This is a comment on the California-American Water Company Monterey Peninsula Water Supply Project DEIR. Submitted 9/30/2015

Water Rights

Single Geologic Aquifer

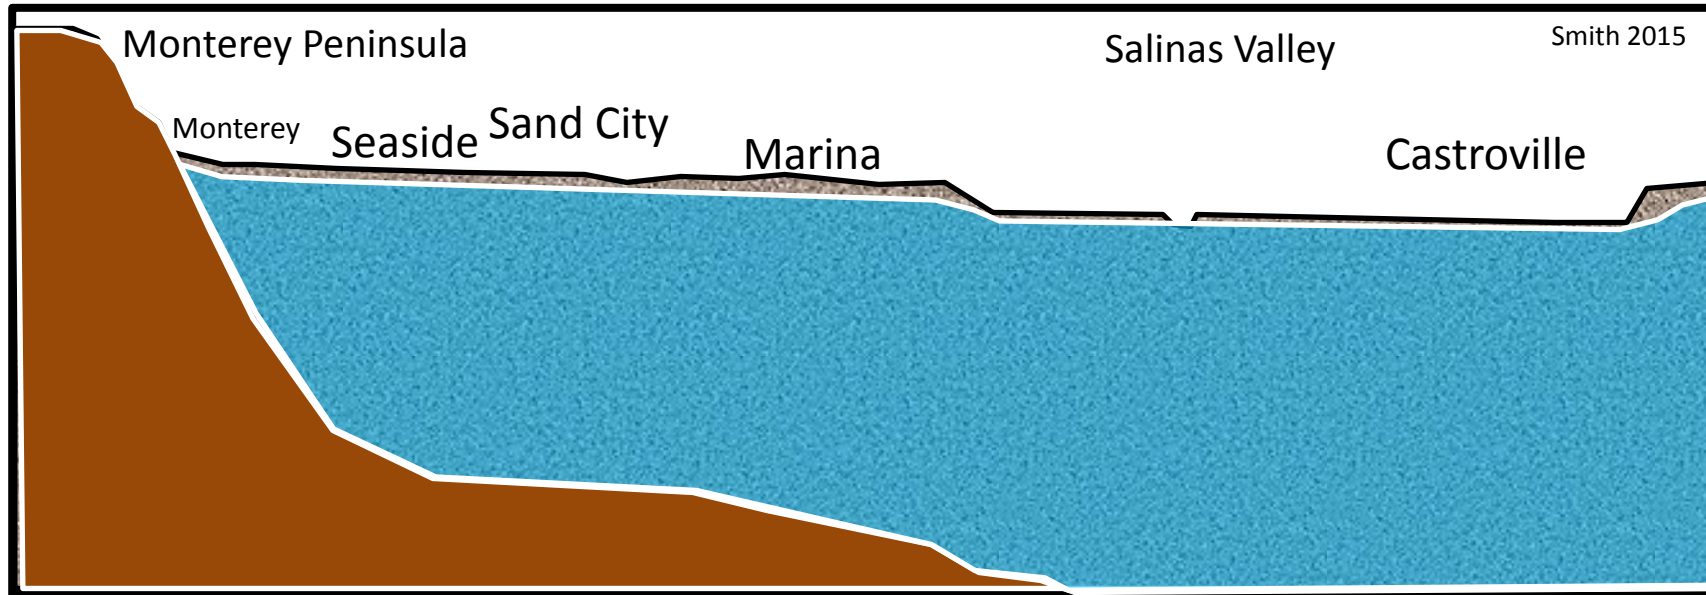
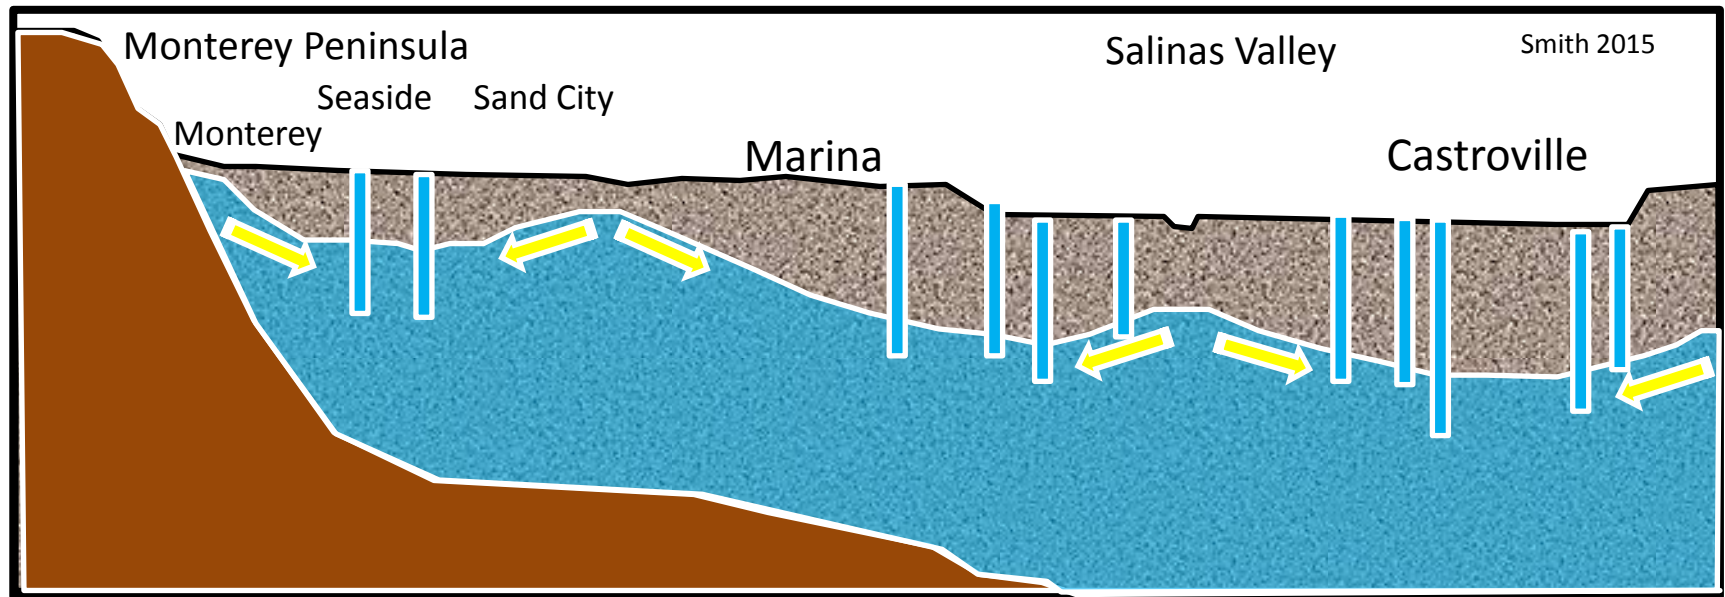
The Seaside Basin and Salinas River Basin share the same water (Figures Below). There is no physical geological barrier to groundwater flow between the basins. Water flows to one set of pumps or another strictly based upon pressure gradients, not a physical divide. The current delineation between the Seaside Basin and Salinas groundwater basin is a ridge in the water table. Water on the north side flows to the Salinas basin and water on the south of the ridge flows to the Seaside basin. The ridge is a relict of unsustainable groundwater use in both regions (Figures Below). The overuse has dropped the water table down around wells, leaving a ridge under Fort Ord lands. The ridge can move, based upon which side uses more water. It is an ephemeral feature that should not be used to legally define water basins.

Two basins separated by artifact of unsustainable use
